Responses to reviewers' comments on the manuscript "Effect of tidal stream power generation on the region-wide circulation in a shallow sea", by G. I Shapiro. Submitted to Ocean Science Discussions (OS-2010-47).

REFEREE #2.

New Fig1. Thrust coefficient (left) and generated power (right) vs flow speed

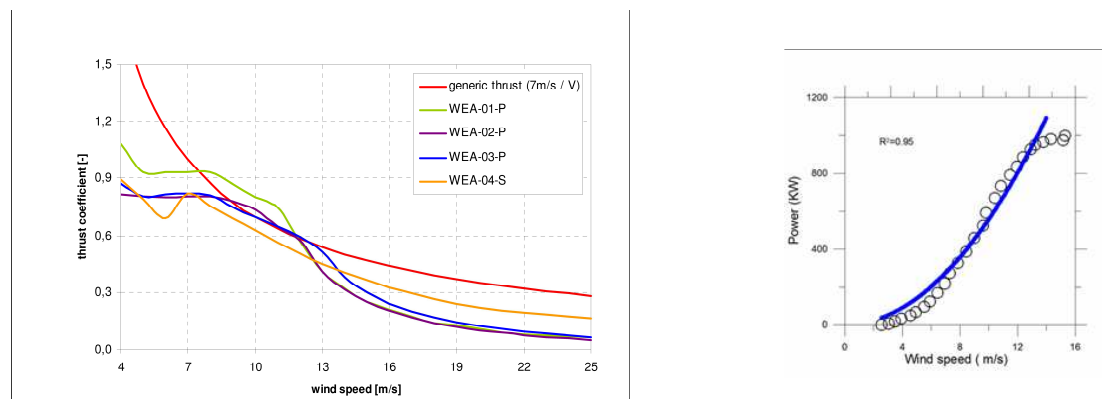
COMMENT: Choosing a linear, Rayleigh, drag, rather than a more realistic quadratic drag, seems curious and unnecessary.

RESPONSE: I cannot agree that a quadratic drag 'is more realistic'. Quadratic drag (and hence the assumption of the constant drag coefficient) is commonly used for

description of flow around static objects, but such an assumption is not suitable for the flow dynamics through turbines. In this case the thrust coefficient (a term used instead of drag in the fluid dynamics of turbines) decreases as speed increases resulting in a linear drag law. More details are given in response to referee #1, and a new sub-section, literature references and a sub-figure to Fig.1 are added to the manuscript to clarify this issue. Basically the difference is that in a turbine the loss of pressure (retarding force) is mainly caused by transfer of momentum to the rotation of blades rather than by creating turbulence.
